**MODIFICATION REQUEST:**

***One Central Park (Block 2), 26 Broadway,  
Chippendale (former Carlton United Brewery site)***

***MP 09\_0078 MOD – 1 Modification to Approved  
Building Layout***

Director-General's Environmental Assessment Report  
Section 75W of the  
*Environmental Planning and Assessment Act 1979*

**Figure 2:** Comparison of Concept Plan (green) to proposed amended design (yellow) as contained in EA

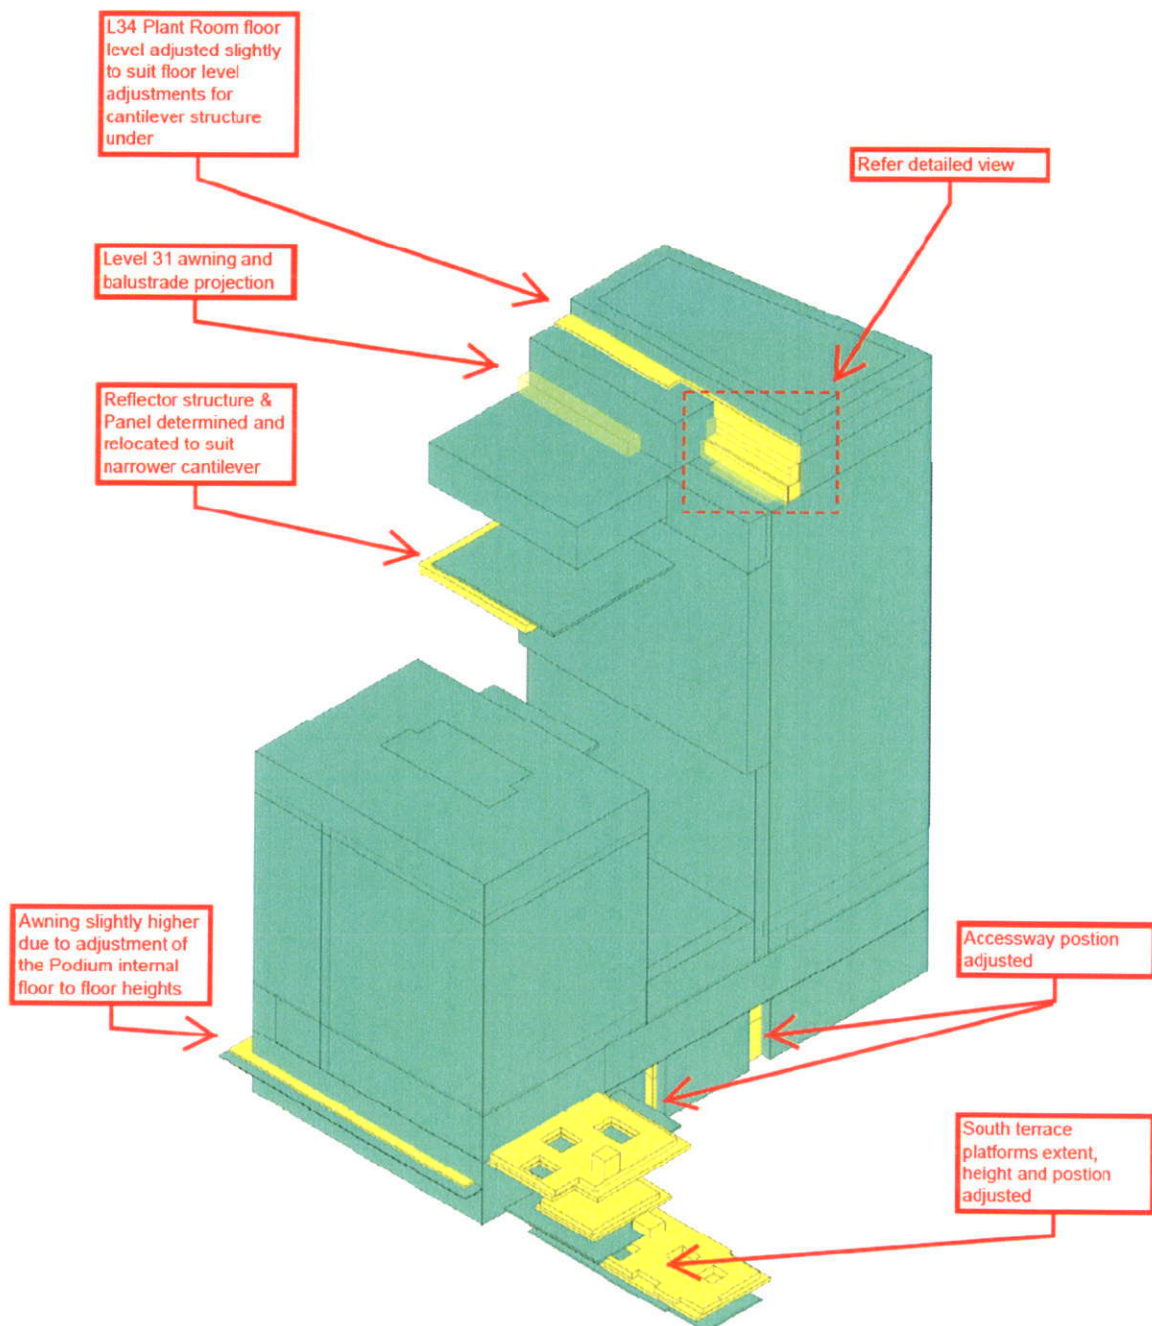
The plans approved within the Concept Plan (as modified) identify approved building envelopes and heights for Block 2. Minor modifications are proposed to the approved Concept Plan envelope (**Figure 2**), however no concerns are raised with these modifications, as the modifications do not significantly alter the Concept Plan building envelope.

**Figure 3:** Solar access diagram of modified design as contained in EA (red shading indicates apartments that do not comply with SEPP 65 requirements for solar access and blue are apartments that do comply with SEPP 65 requirements). Green circle indicates units provided with reduced amenity.

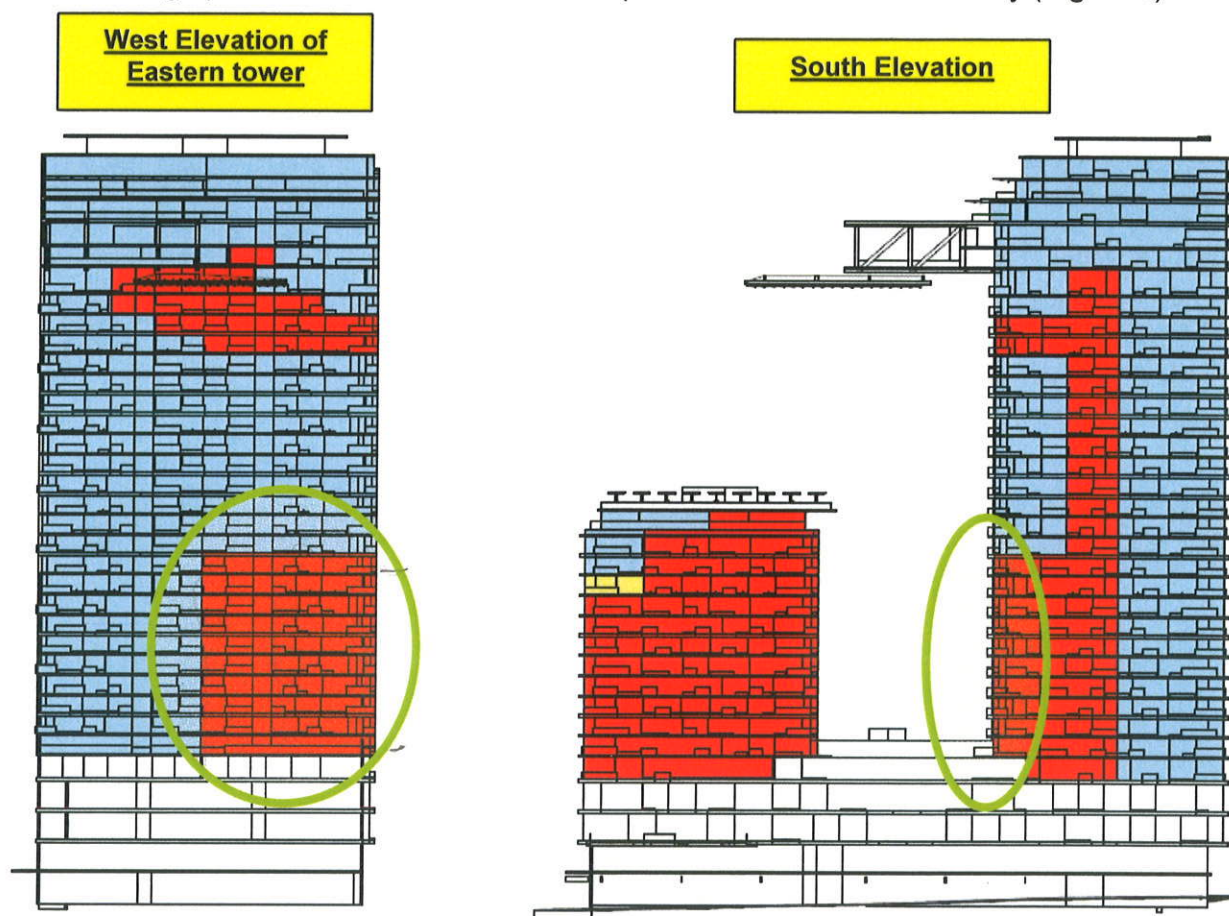
- East Tower
  - Apartment 12 on Level 5, 6, 9 and 12 (smaller apartment of the 2 bed 2 key apartment is provided with an area of 28.7m<sup>2</sup> including half of the common area) receives no cross flow ventilation and less than 2 hours of sunlight access. The apartment is provided with an area of outdoor open space over the common area between the two

towers. Despite this outdoor open space area, the amenity of the apartment is reduced due to the above issues.

- Apartment 12 on Level 7, 8, 10, 11 (smaller apartment of the 2 bed 2 key apartment is provided with an area of 32.6m<sup>2</sup> including half of the common area) receives no cross flow ventilation, less than 2 hours of sunlight access and does not include an area of outdoor open space. View is provided west over common area between the two towers.

- Apartment 12 provided on Level 4 receives no cross flow ventilation, less than 2 hours of sunlight access and does not include an area of outdoor open space. A view is provided to the south towards Block 5A/5B.

- Apartment 04 and 05 provided on Level 4 receives no cross flow ventilation, less than 2 hours of sunlight access and does not include an area of outdoor open space. A view is provided to the south over the landscape platforms towards the Main Park.

In order to improve the amenity of the apartment, it is recommended that the apartment be amended and replaced with a 2 bedroom apartment (not 2 key).

In order to improve the amenity of the apartment, it is recommended that the apartment be amended and replaced with a 2 bedroom apartment (not 2 key).

To improve the amenity of this apartment, it is considered that a balcony be provided off the living area to provide an area of outdoor open space.

To improve the amenity of this apartment, it is considered that a balcony be provided off the living area to provide an area of outdoor open space.

- the conversion / deletion of 8 dual key apartments in the eastern tower to two bedroom apartments only; and
- the addition of a balcony to 2 studio apartments in the western tower and 1 studio apartment in the east tower.

**Figure 4:** Revised operation of heliostat illustrating sunlight reflections as contained in EA

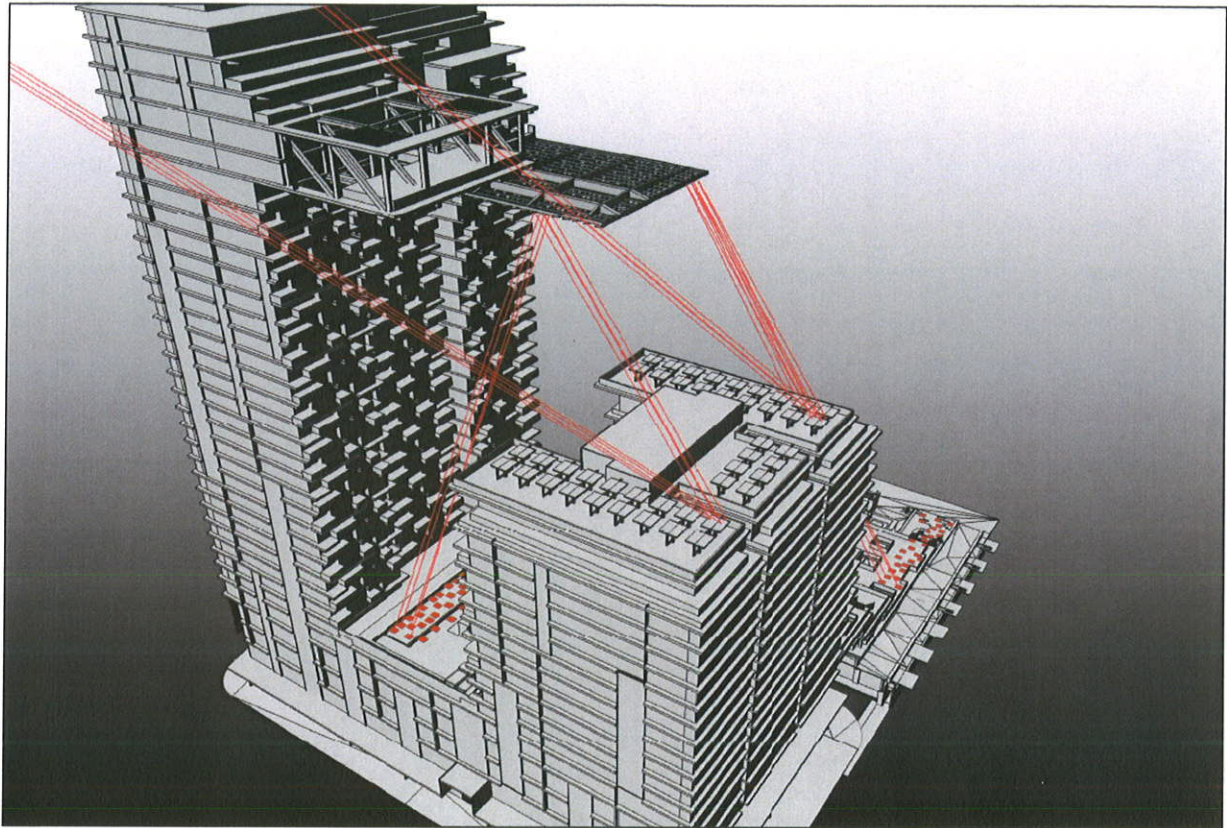
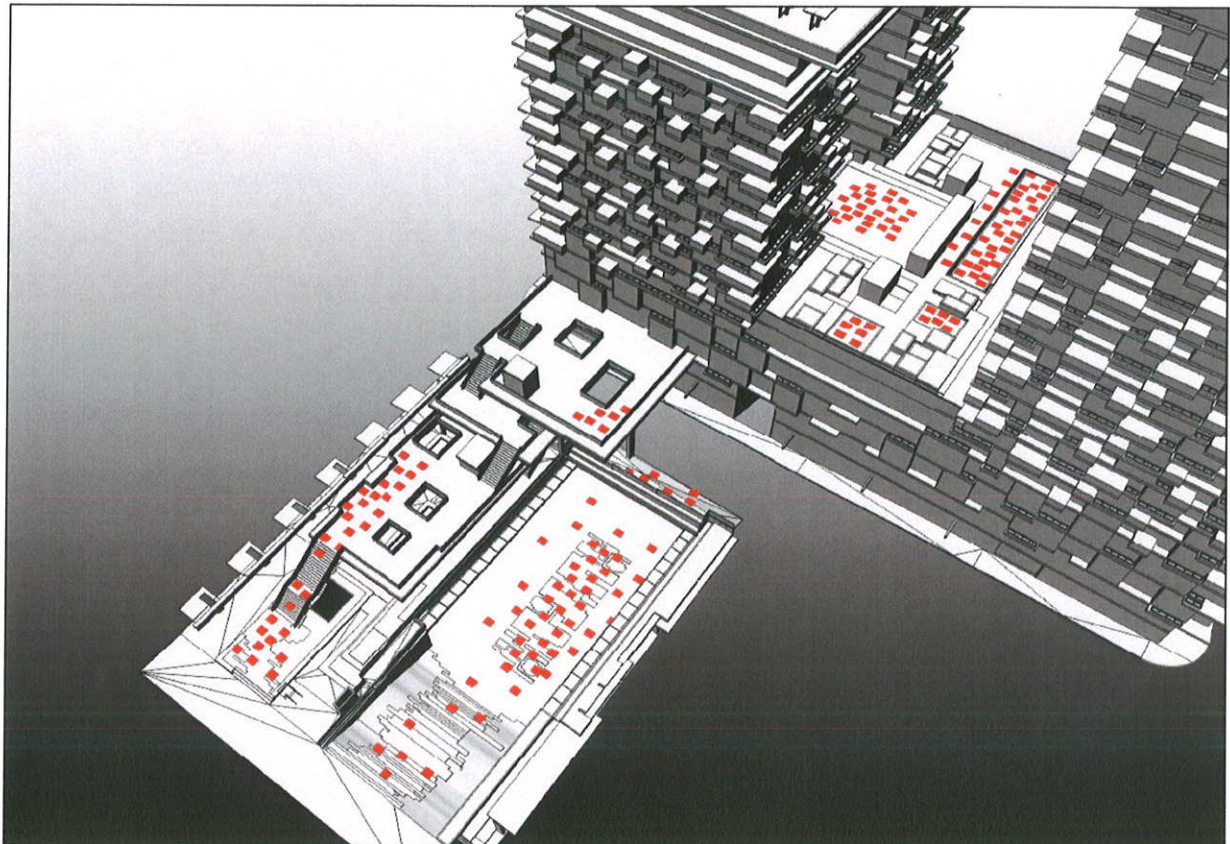
- the deletion of the western tower heliostat;
- increase to the number of reflective mirrors on the western tower rooftop from 12 to 48 mirrors (mirrors reflect the sunlight to the heliostat provided on the eastern tower); and
- modification / retention of the eastern tower heliostat with the inclusion of additional mirrors (from 97 to 324) and an increase in size of the heliostat from 22m x 26.2m to 23m x 26.96m.

The Proponent advises that previously the original heliostat produced small patches of light with large mirrors. The modified design proposes mirrors that track the sun, which will therefore make the most out of the available sunshine thereby producing more reflected light throughout longer periods of the year.

From the diagrams submitted in support of the amendment, additional reflected sunlight is proposed to areas between the two towers (containing a spa deck, outdoor pools and landscaped areas) and the landscaped platforms and piazza area to the south. Additional sunlight to these areas is supported as this will enable greater use of the overshadowed areas throughout the year.

The deletion of the western tower heliostat has also reduced the overshadowing from this element onto the open space areas to the south, which is also supported.
